Access Compliance Report

Public Rights-of-Way

(Curb Ramps)

Intersection ID: 53349	Main Street: SAPPHIRE_HILL_LN	Cross Street: N/A	Location: SE
ADA ID: 13ABEB6A357E	Ramp Type: Perp	Initial Pass/Fail: Pass	Overall Compliance: No
			Severity Score: 5

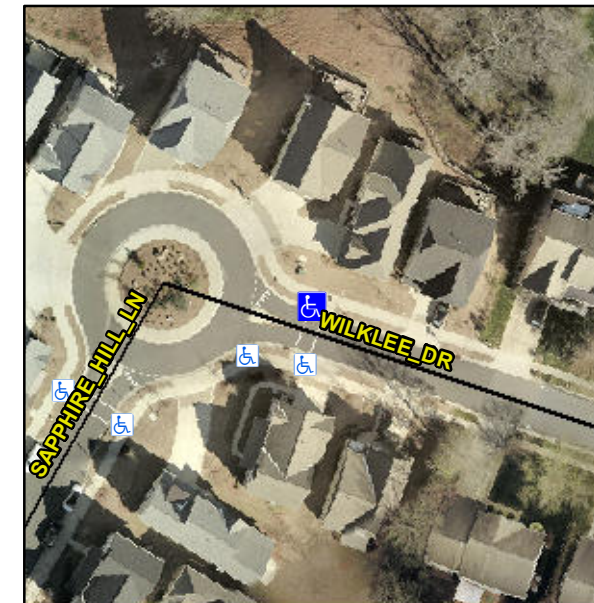
**R304.2.2-Perp, R304.3.2-Para,
R304.5.4, R304.5.3**

Compliance	Description	Data	Compliance	Description	Data
N/A	Ramp Length (in)	41.0	Yes	Ramp Slope (%)	6.3
Yes	Ramp Width (in)	62.0	Yes	Ramp XSlope (%)	0.5
N/A	Flare Type LT	Sloped	N/A	Flare Type RT	N/A
N/A	Flare Slope LT (%)	7.2	Yes	Flare Slope RT (%)	6.5
N/A	Flare Traversable LT?	Yes	N/A	Flare Traversable RT?	Yes
Yes	Landing Length (in)	72.0	Yes	DWS Provided?	Yes
Yes	Landing Width (in)	62.0	Yes	DWS Contrast?	Yes
No	Landing Slope (%)	2.1	Yes	DWS Length (in)	24.0
Yes	Landing X Slope (%)	2.0	Yes	DWS Full Width?	Yes
N/A	Landing Curb? (Y/N)	No	Yes	DWS Offset (in)	2.0
N/A	Shared Landing?	No			
Yes	Gutter Ponding?	No	No	Gutter Slope (%)	5.3
Yes	Gutter Lip Ht (in)	0.0	No	Gutter X Slope (%)	2.3
N/A	Painted X Walk1?	Yes	N/A	Painted X Walk2?	N/A
	X Walk 1 Direction	To SW		X Walk 2 Direction	N/A
N/A	X Walk 1 Width (in)	87.0	N/A	X Walk 2 Width (in)	N/A
	X Walk 1 Slope (%)	1.9		X Walk 2 Slope (%)	N/A
	X Walk 1 X Slope (%)	2.3		X Walk 2 X Slope (%)	N/A

Remove & Replace Landing.
Remove & Replace Gutter.
